**GENERAL INFORMATION**

Location: 9555, 10001, 10009, 10017, 10027 and 10029 Lyndale Avenue South

Request: 1. Comprehensive Land Use Guide Plan Amendment to change the land use designation of 9955 Lyndale Ave S from General Business to High Density Residential;  
2. Rezone from B-2 and R-1 to RM-50(PD) High-Density Residential (Planned Development);  
3. Preliminary and Final Development Plans for a four-story, 180-unit multi-family residential building; and  
4. Preliminary and Final Plat to combine six parcels into one.

## PROPOSAL

**Figure 3: Front Setback Variability**

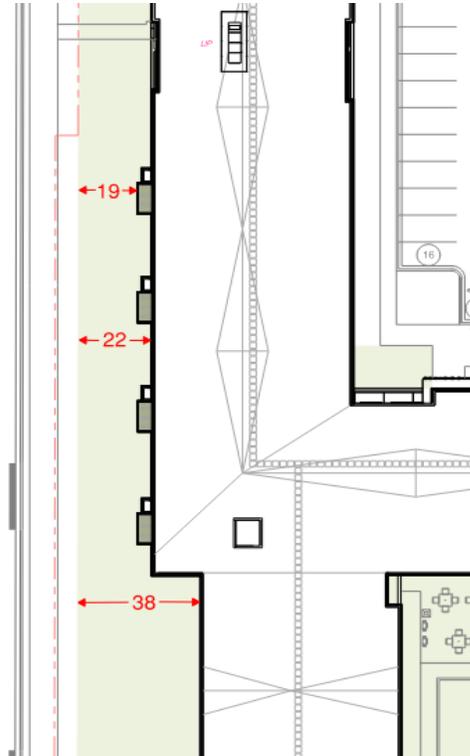
The building meets the required side and rear yard setbacks; however, the applicant is requesting development flexibility for the front yard setback. The Code requires a setback of 40 feet from the front property line, where a minimum of 19 feet 7 inches is proposed. The front setback varies at different parts of the building, as shown in Figure 3 below. Staff is supportive of the proposed deviation because the reduced setback enhances the building's presence along Lyndale Avenue, facilitates pedestrian access, and reinforces the corridor's urban character. Locating the building closer to the street shifts the proposed building further away from existing low density residential uses to the east.

**Figure 5: Residential Step Back Flexibility Required – Site Plan View**

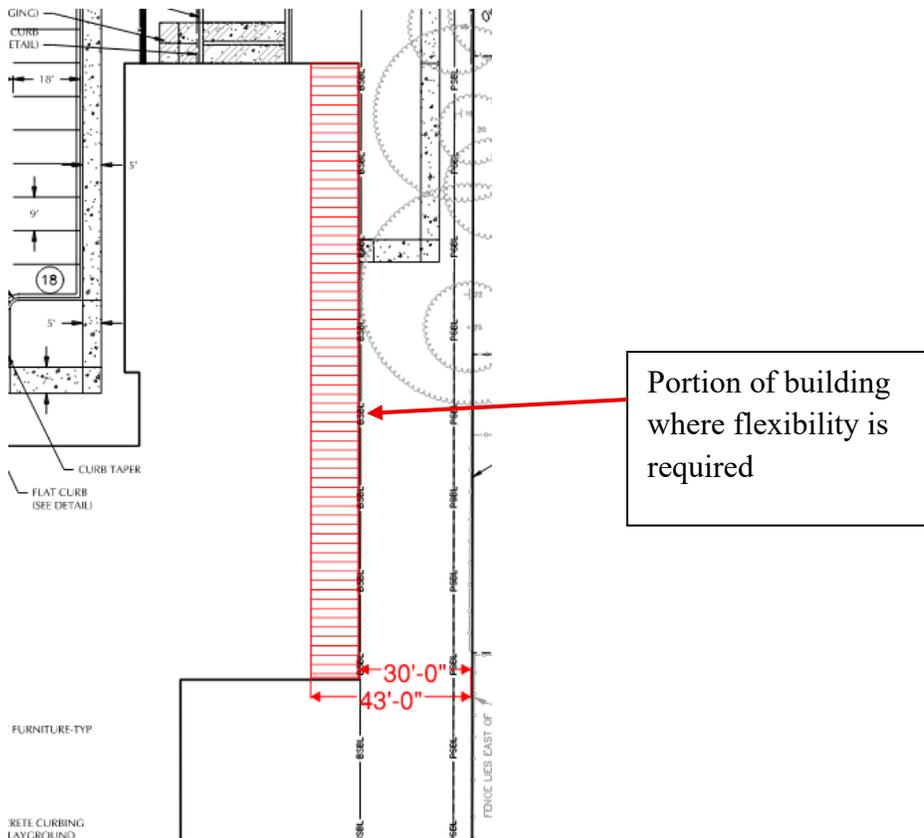
The applicant is also requesting flexibility on the required step back from protected residential properties found in the City’s height standards. The Code requires a 1:1 step back ratio from the closest protected residential property line based on building height, which in this case would require a 43-foot setback from the rear property line, where only 30 feet is proposed. Figure 4 illustrates the requested flexibility in elevation view, while Figure 5 illustrates the requested flexibility in site plan view. Staff is supportive of this deviation, as the shadow study submitted by the applicant indicates minimal shadow impacts on adjacent residential properties. The design of the building includes a flat roof, limiting overall structure height (43 feet). In addition, the reduced step back allows for greater development density, supporting the creation of additional housing along an arterial roadway in proximity to transit service, consistent with the Lyndale Avenue Suburban Retrofit Plan and the 98th Street Station Area Plan. Further, the Planning Commission recently recommended City Council approval of an ordinance that would amend the City’s building height map. One of the recommended changes related to the residential step back provision. Should the City Council adopt the ordinance as recommended by the Commission, the development flexibility pertaining to residential step back requirements would no longer be necessary, as the properties east of the subject site are guided Medium Density Residential in the future land use map of the Comprehensive Plan.

Portion of building where flexibility is required

Overall, staff finds that the flexibility requested as part of the Preliminary and Final Development Plans meet the required public benefit test and are within the parameters allowed within the Planned Development (PD) Overlay Zoning District.
